**CERTIFICATE OF APPROPRIATENESS**

**Property:** 903 Harold St, Tracts 1 and 2, Block 29, Montrose Subdivision. The property includes a historic 3,112 square foot, two-story wood frame single-family residence situated on a 7,800 square foot (65' x 120') corner lot.

**Proposal:** Alteration – Windows

**FIRST FLOOR PLAN\***  
 EXISTING

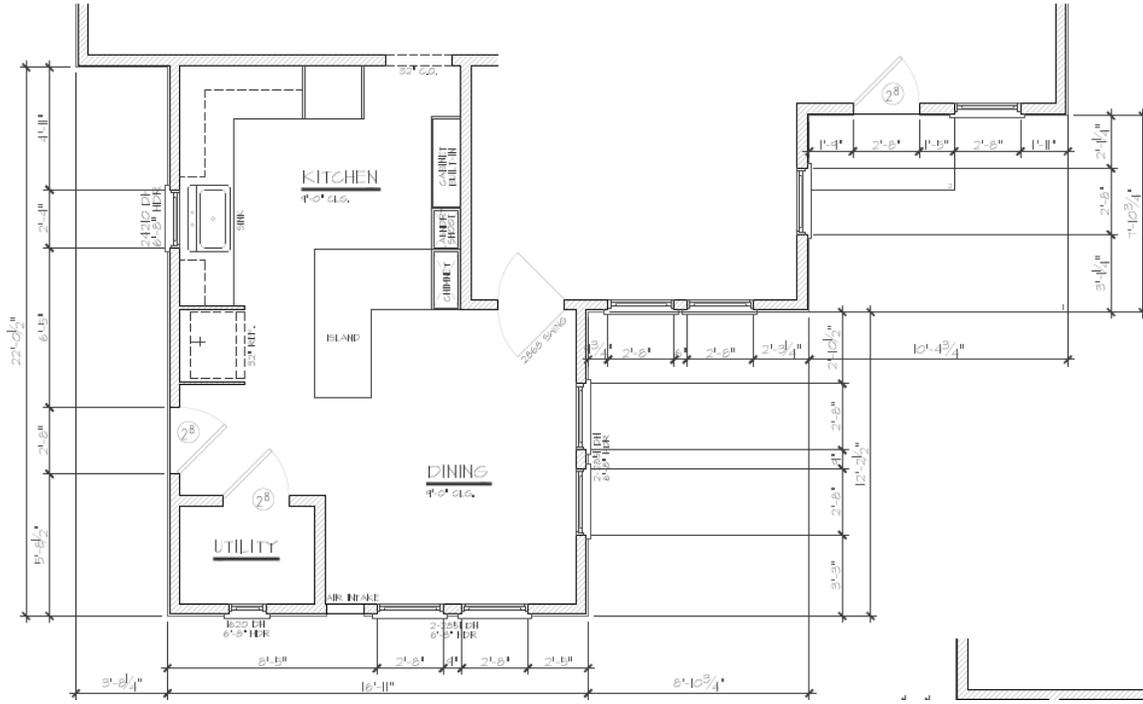
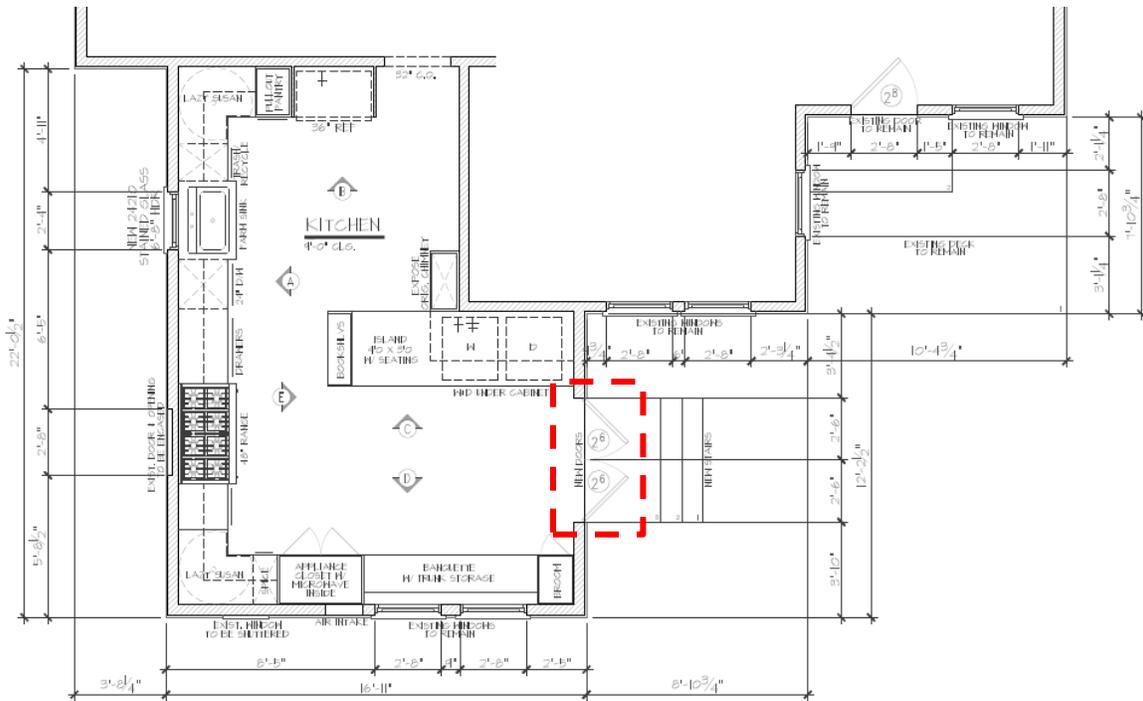
- Remove two double-hung wood windows from the first level on the east side elevation and replace with a set of two mahogany doors. Each door will measure approximately 2'-6" wide by 6'-9" tall and feature new trim. The set of doors will not exceed the width of the existing opening, and will elongate the opening by approximately 2'. The header height will remain the same. The wood windows will be salvaged for future repairs.
- Shutter one fixed window on the south (rear) elevation; remove one double-hung window and replace with a stained glass window on the west side elevation; shutter one door on the west side elevation. Proposed alterations to the south and west elevation are not visible from the public right of way, but are included here for reference to overall scope.
